**WOODFORD COUNTY BOARD OF EDUCATION
AGENDA ITEM**

TOPIC/TITLE: WCHS Project Change Order

Woodford County High School Phase 2
145 School House Road
Versailles, KY 40383

DATE:	06/30/2023	PR #:	PR 084
TO:	Travis Curry – Trace Greek Construction	RE:	Woodford County Board of Education Versailles, Kentucky BG 19-353 RTA 1916

SD2.3, PR84.2, PR84.3

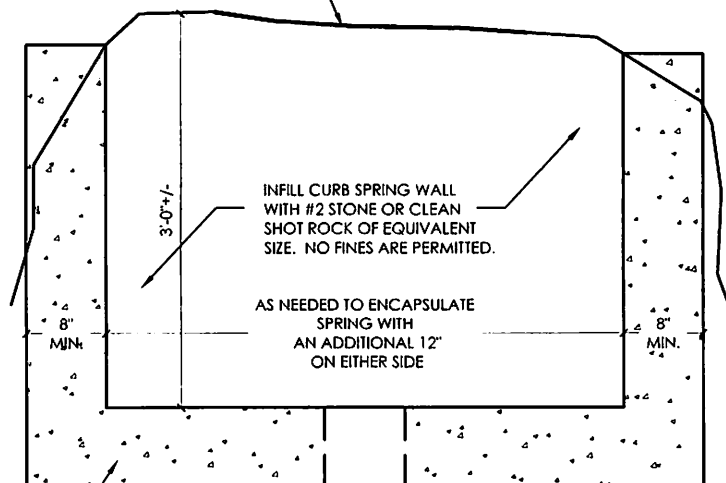
1. Provide spring remediation at parent loop as shown in attached sheets.
 - a. Pricing is to be submitted in two parts:
 - i. Part A of the pricing is to include:

1. Labor and materials to install the 6" French drain in the existing drainage swale and connect to drainage structure DS-63 as shown. French drain shall be installed in conformance with detail E/SD4.1

2. Labor and materials to include the removal and re-installation of the newly planted trees along School House Road. Remove and relocate trees to be 4'-0" from the school side of the adjacent sidewalk. Contractor to repair sod as necessary to provide uniform lawn.

SPRING CURB WALL

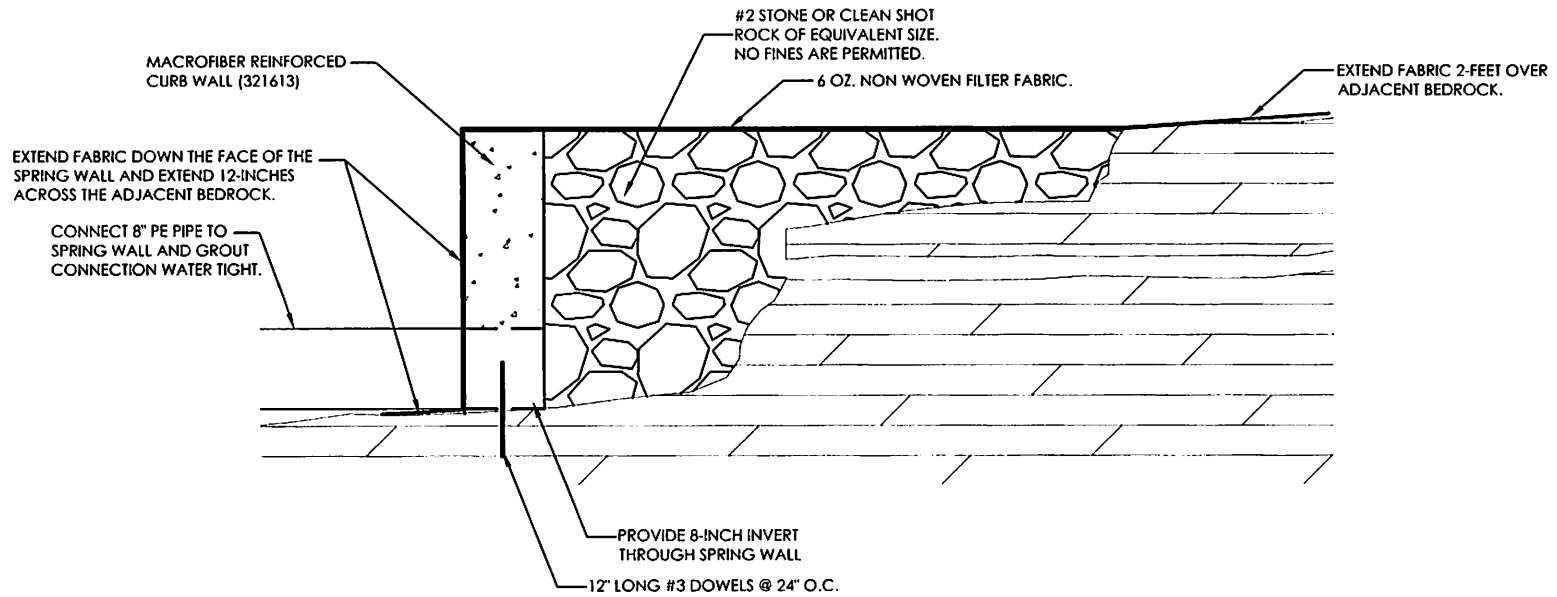
IDENTIFIED EXTENTS OF
SPRING WHERE IT DAYLIGHTS
THROUGH THE BEDROCK

MACROFIBER REINFORCED
CURB WALL (321613)

CONNECT 6" PE PIPE TO
SPRING WALL AND GROUT
CONNECTION WATER TIGHT.

NOTE:
FULLY ENCAPSULATE THE SPRING WITH NEW
CURB WALL. BEDROCK SURFACE IS TO BE
CLEANED OF ALL DEBRIS AND SOIL MATERIALS
PRIOR TO INSTALLATION OF CURB WALL.

3. Labor and materials to include hydroseeding of disturbed area.
 - ii. Part B of the pricing is to include:
 1. Labor and materials to install spring box as detailed on sheets PR84.2 and PR84.3

2. Labor and materials to remove and replace existing asphalt and striping at the bus loop to install the new spring box.
